JINDAL ALUMINIUM LTD.
BANGALORE-560073 (INDIA)

NAME	DATE
DRAWN	PARVESH	19-10-2013
CHECKED		
APPROVED	S.S.GARG	19-10-2013
SCALE		0.5:1
AREA mm ²		1338.613
PERIMETER mm.		519.813
WEIGHT kg/m		3.614
DRAWING No.		SECTION No.
P-12319		-
10434		10434(ISSUE-3)

PARTY'S NAME	BANGALORE MARKET (ROLLING MILL DIVISION)
PARTY'S DRAWING No.	AS PER SPECIFICATION
ALLOY & TEMPER	19700
DESCRIPTION	FLAT BAR

P-12319

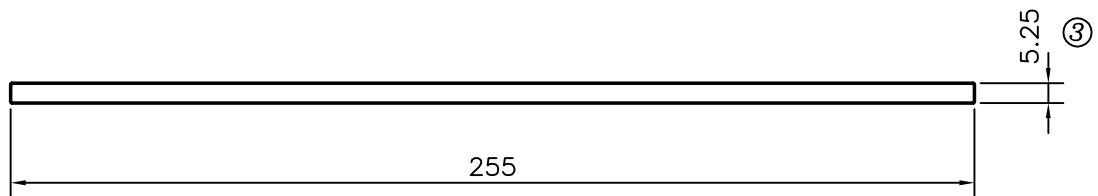
ISSUE (2) :-

☞ TOLERANCE ADDED ON THICKNESS.

ISSUE (3) :-

☞ THICKNESS CHANGED FROM 4.2 TO 5.25 mm.

☞ WEIGHT ALSO CHANGED FROM 2.891 Kg/M. TO 3.614 Kg/M.
